LONDON BOROUGH OF CAMDEN PLANNING DEPARTMENT

Objection to Planning Application Ref **2016/5336/P
WAREHOUSES at 1A Highgate Road**

Highgate Park Factory
 1A Highgate Road

Existing and Proposed Elevations

B-Existing Rear Elevation

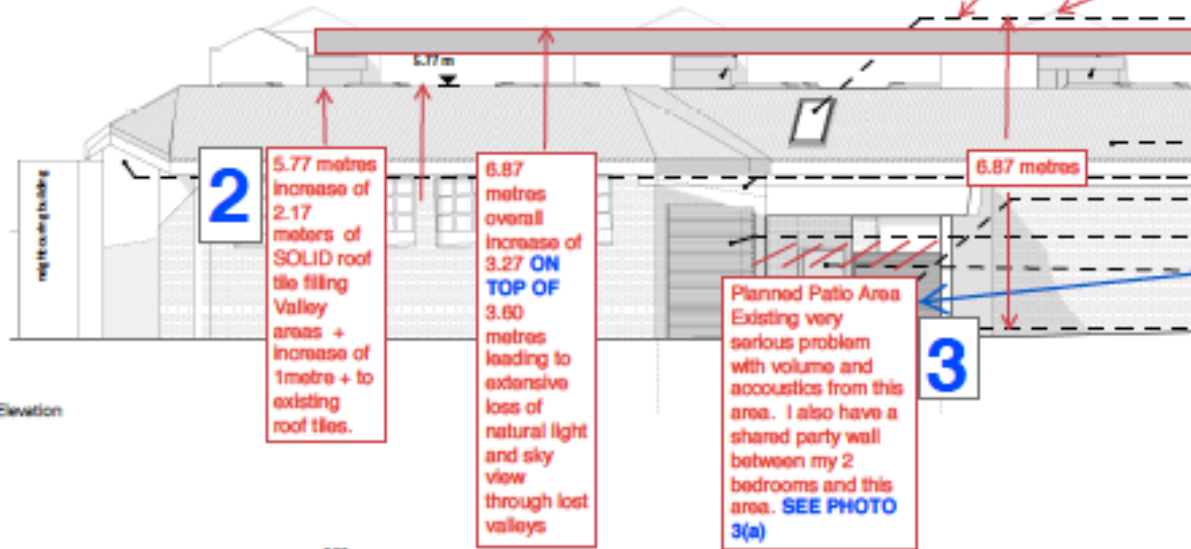
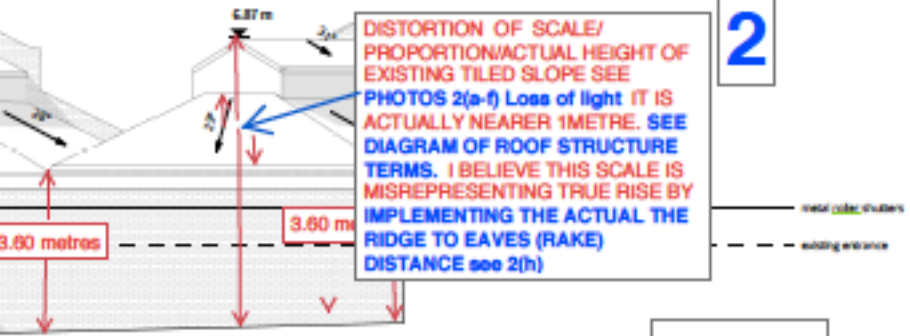
DISTORTION OF SCALE/ PROPORTION/ACTUAL HEIGHT OF EXISTING TILED SLOPE SEE PHOTOS 2(a-f) Loss of light IT IS ACTUALLY NEARER 1METRE. SEE DIAGRAM OF ROOF STRUCTURE TERMS. I BELIEVE THIS SCALE IS MISREPRESENTING TRUE RISE BY IMPLEMENTING THE ACTUAL THE RIDGE TO EAVES (RAKE) DISTANCE see 2(h)

NO INDICATION OF RISE OF PLANNED ANGLE OR DISTANCE FROM EAVES (how near will actual TALLEST RIDGE LINE BE FROM MY GARDEN WALL AND KITCHEN WINDOWS.)

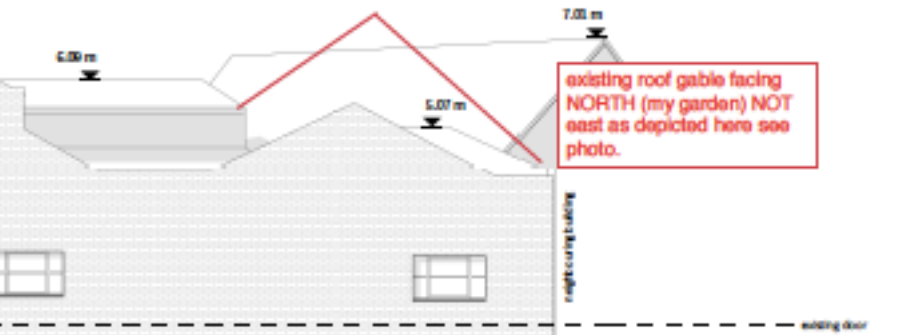
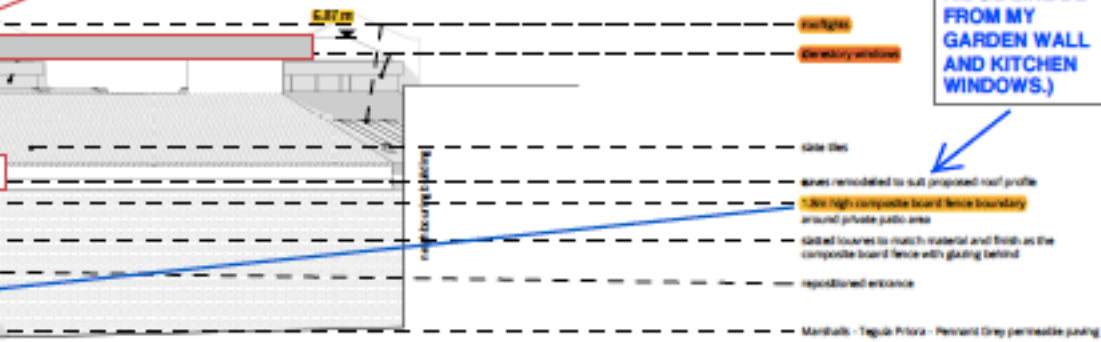
NO BOTH SIDES 0.40???? METRE screeded height to tip of Gables
